UNITED STATES PATENT AND TRADEMARK OFFICE

APPLICATION NO.	FILING DATE	FIRST NAMED INVENTOR	ATTORNEY DOCKET NO.	CONFIRMATION NO.
10/536,576	02/06/2006	Piotr Szwaykowski	TROLOGY 02.02	9931
27667	7590	01/14/2011	EXAMINER	
HAYES SOLOWAY P.C. 3450 E. SUNRISE DRIVE, SUITE 140 TUCSON, AZ 85718			LEE, HWA S	
			ART UNIT	PAPER NUMBER
			2886	
			NOTIFICATION DATE	DELIVERY MODE
			01/14/2011	ELECTRONIC

Office Action Summary	Application No.	Applicant(s)	
	10/536,576	SZWAYKOWSKI ET AL.	
	Examiner	Art Unit	
	Hwa S. Andrew Lee	2886

DETAILED ACTION

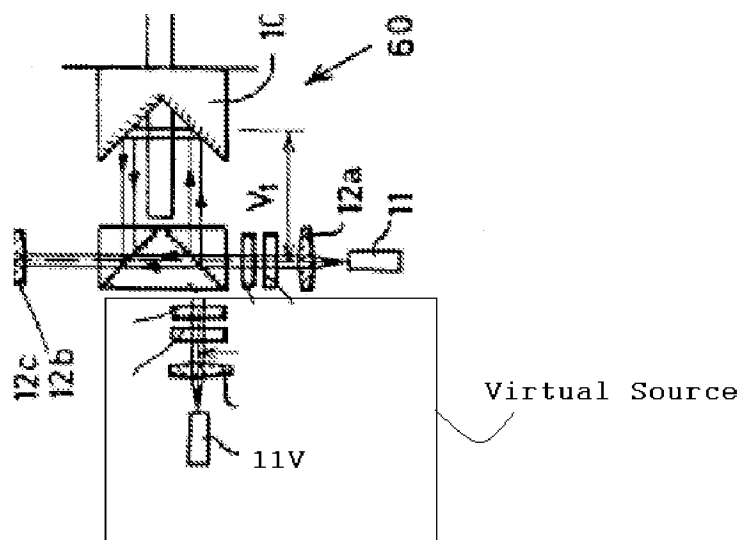
Kuchel show an interferometer for measuring optical phase differences (e.g. Figure 6) comprising:

a reference object (e.g. 14);

a test object (e.g. 16);

at least two spatially separated light sources (11, 11V, please see diagram below showing how there is a source (11) and a virtual source (11V) created by the beamsplitter. The source (11) and virtual source (11V) are spatially separated) that generate mutually orthogonally polarized beams of light, wherein the mutually orthogonally polarized beams of light are spatially displaced with respect to each other (as the beams exit the first polarizing beam splitting mirror, the beams are spatially separated as they are provided to the test and reference objects) as they are provided to at least the reference object and the test object for interaction with said beams; and

a simultaneous phase shifting module (68) receiving at least a portion of said beams after said beams have interacted with said reference object and said test object and generates at least two phase-shifted (67b) interferograms substantially simultaneously from said beams.
